CONTRACT DRAWING

| Title: BOUNDARY TREATMENTS | |
| Job: LAWN ROAD | |
| Dwg. No: FNH413-35.804 | Rev: B |

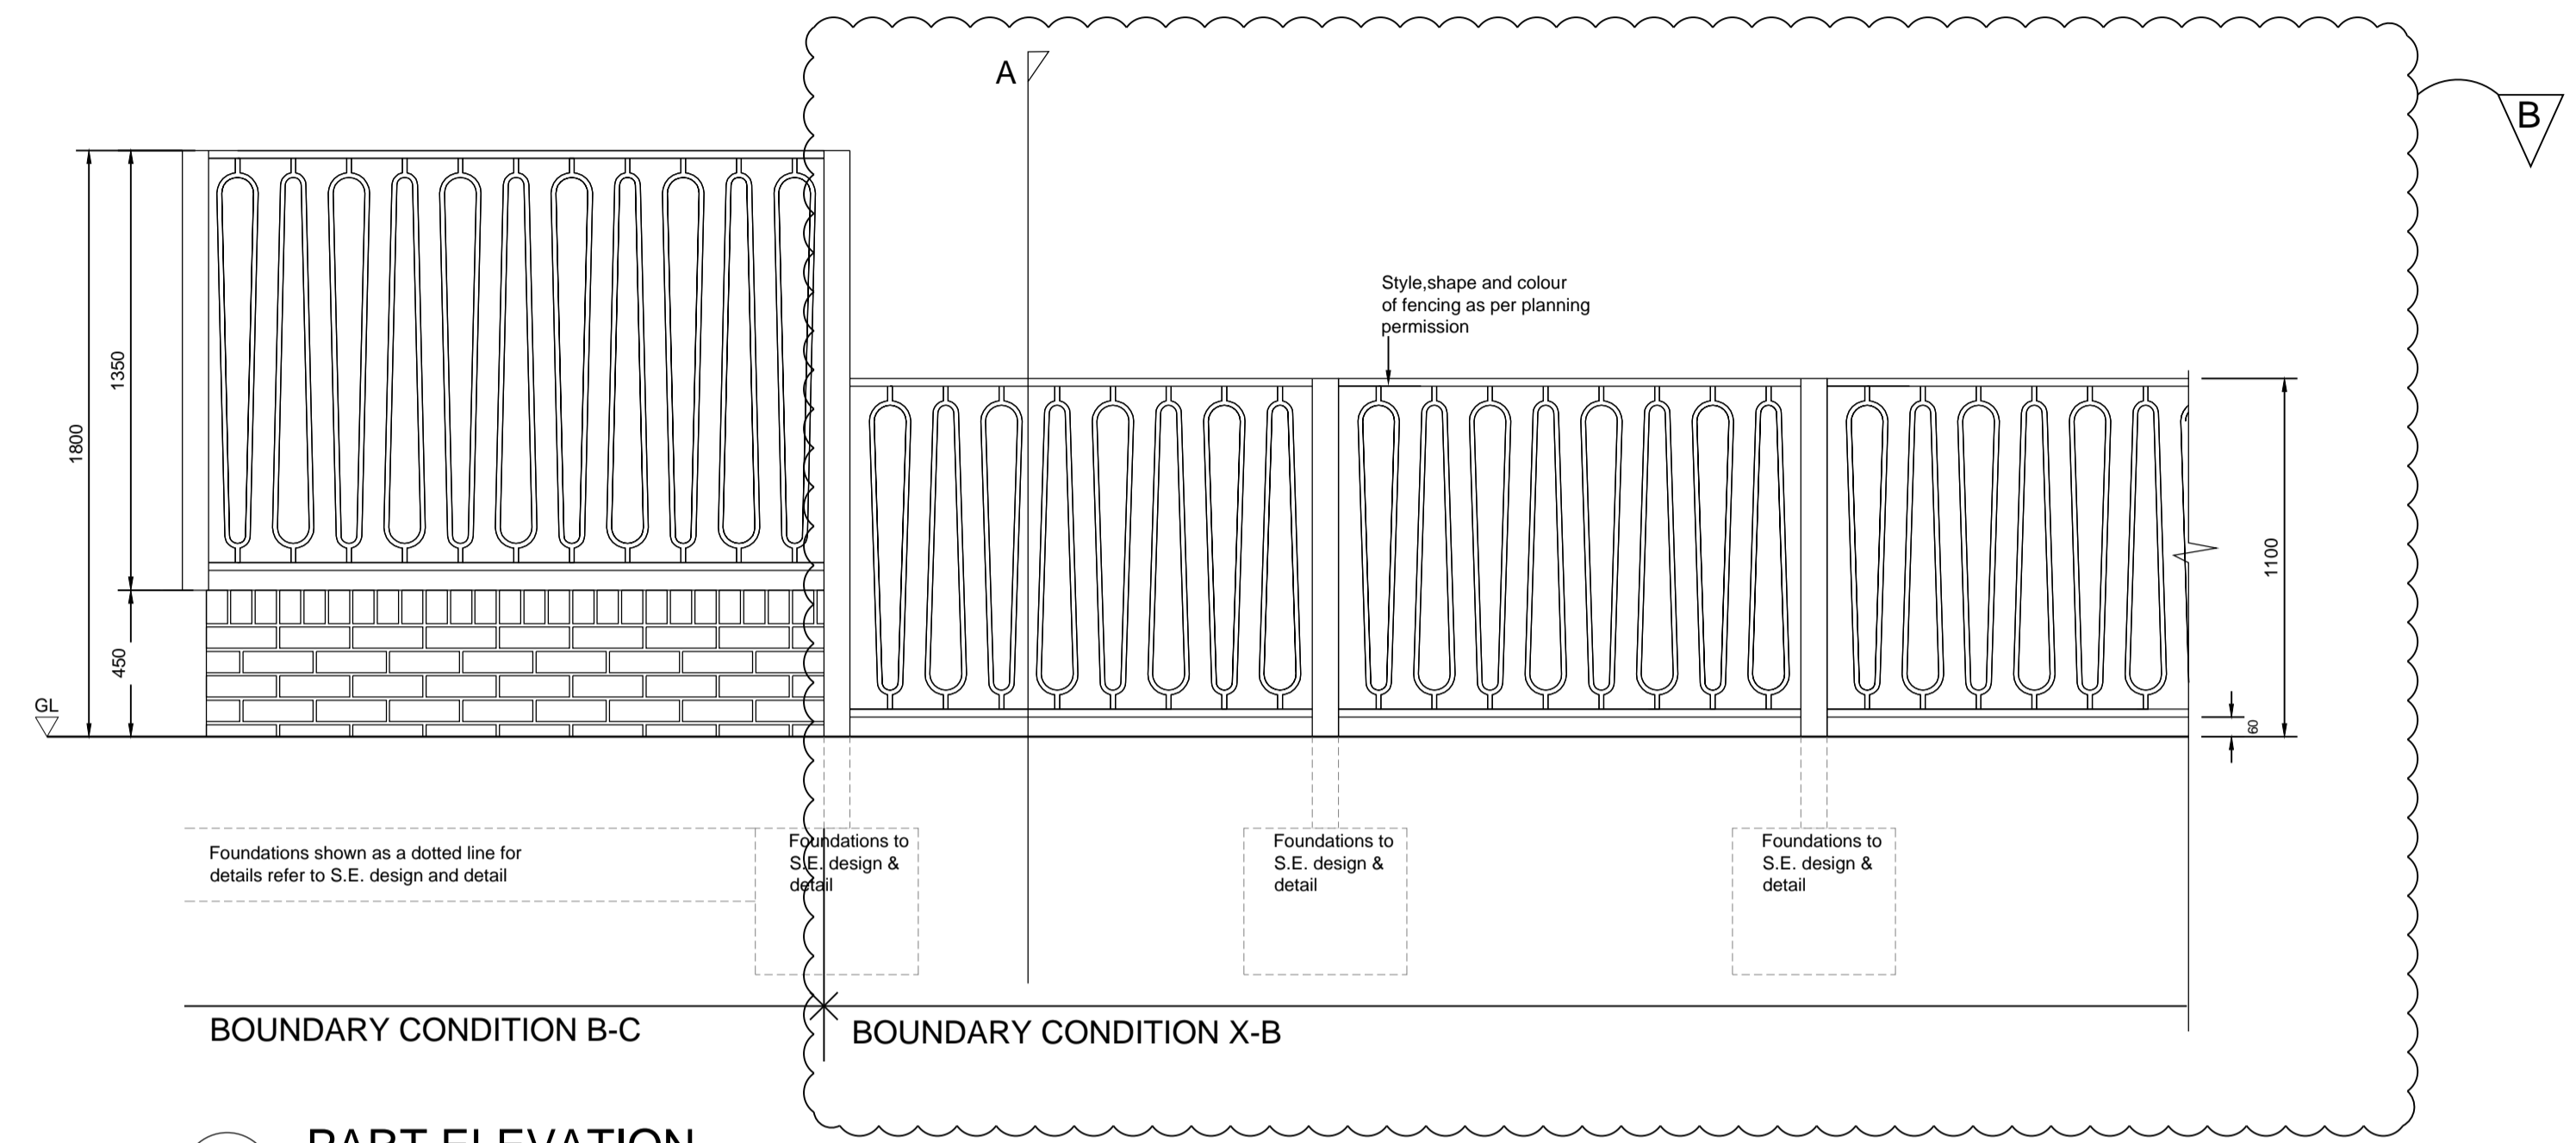
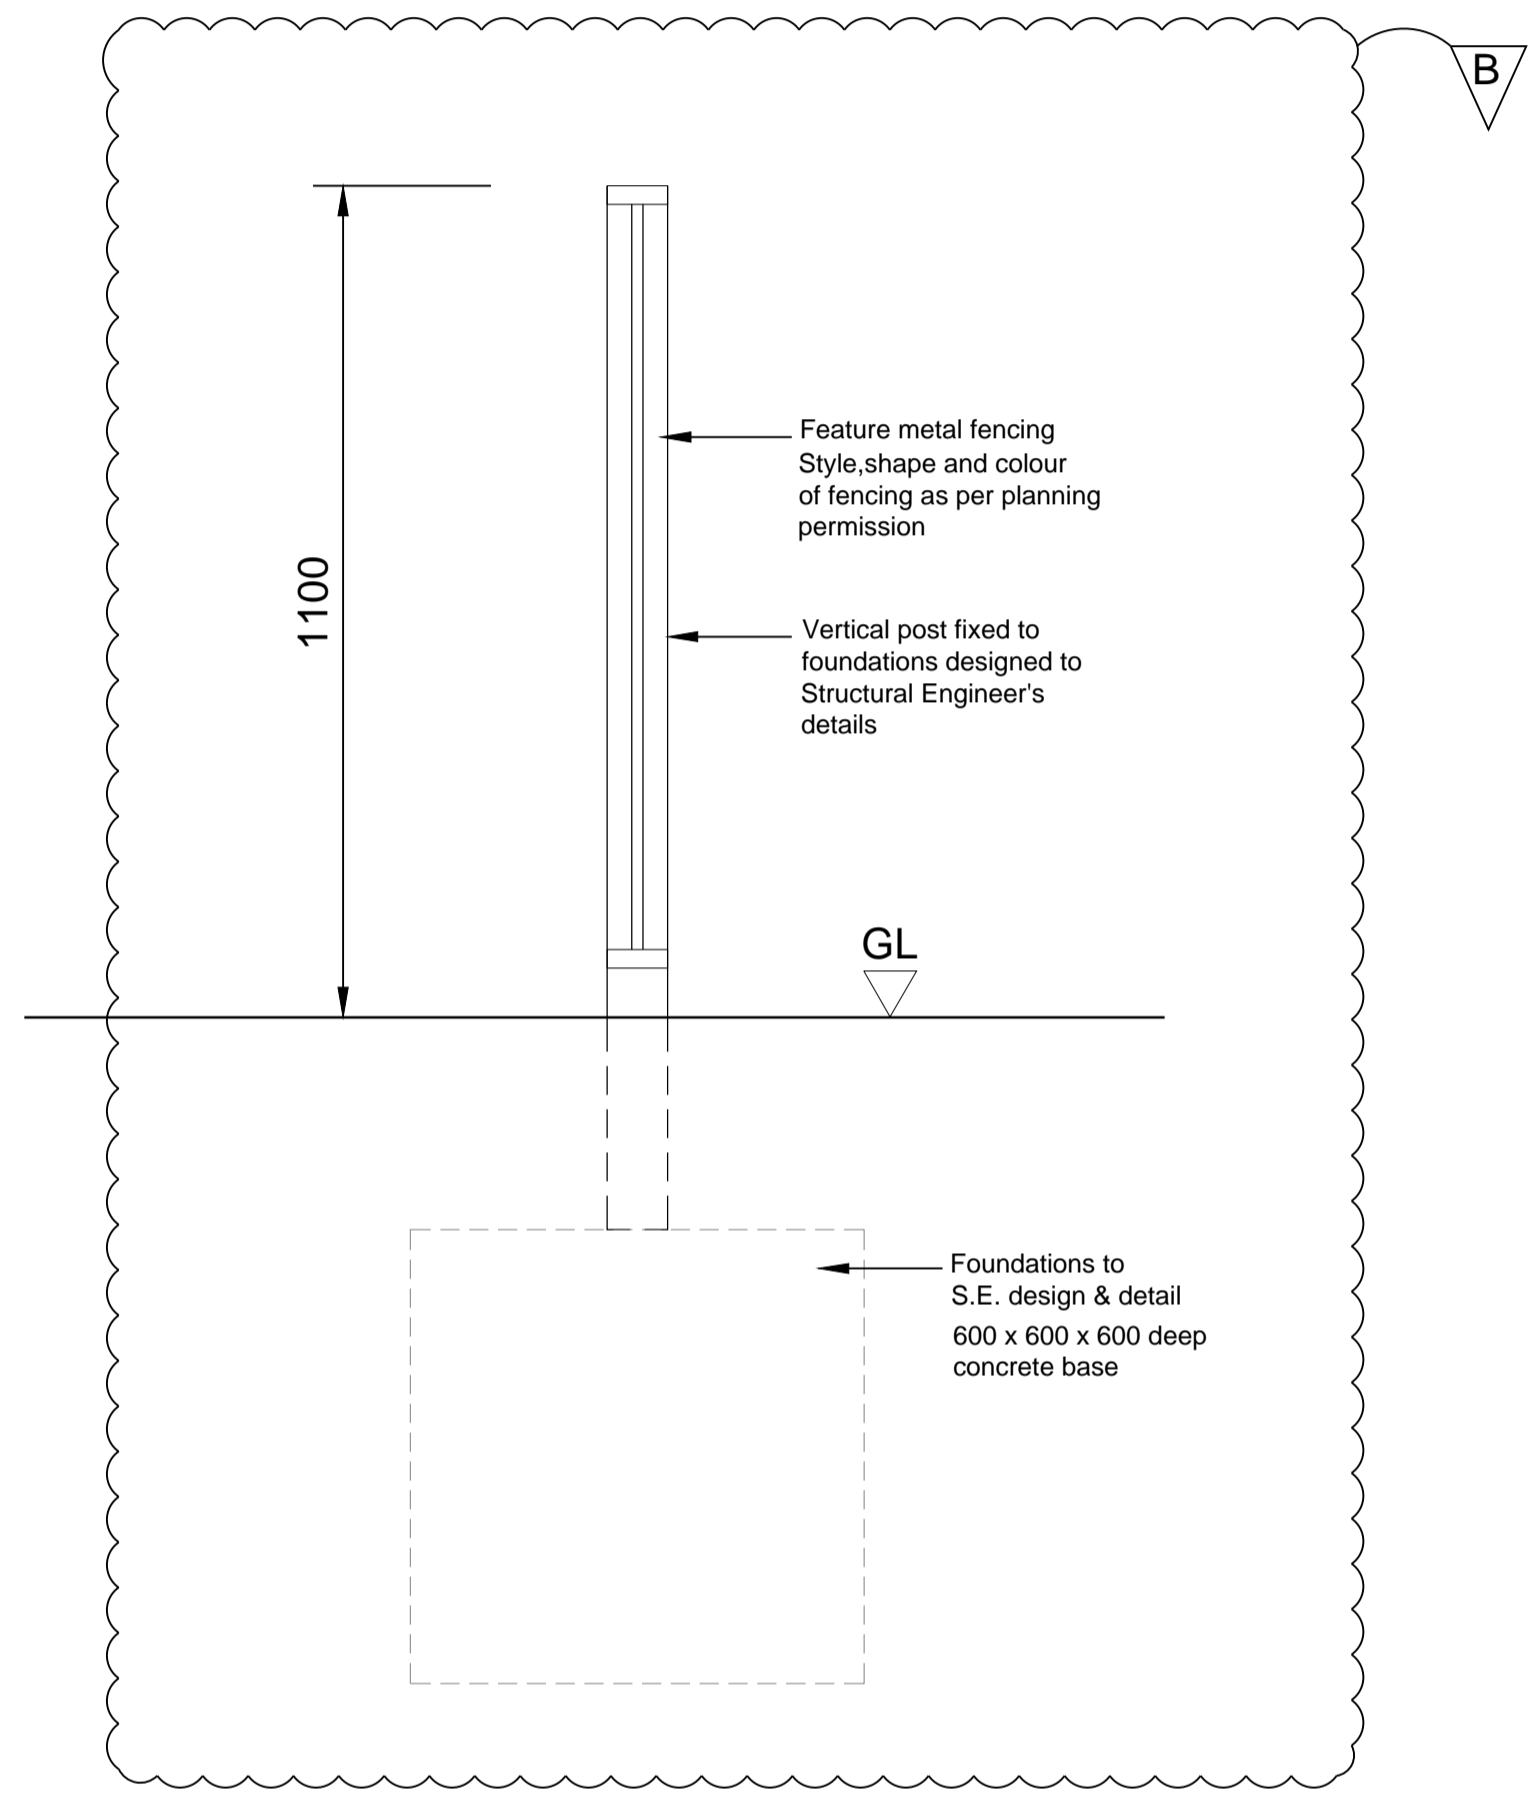
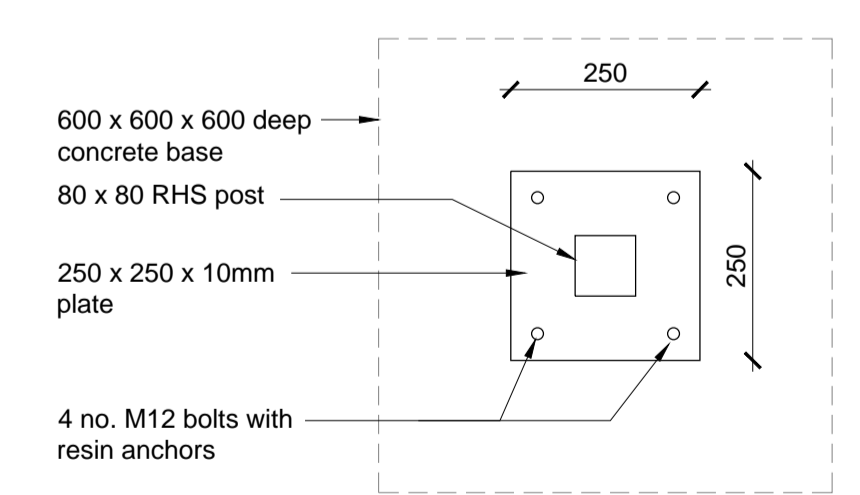
B RFI-4130113- Fence height updated BG 17.06.16
A RFI-4130113- Detail for boundary fence around trees LG 09.06.16
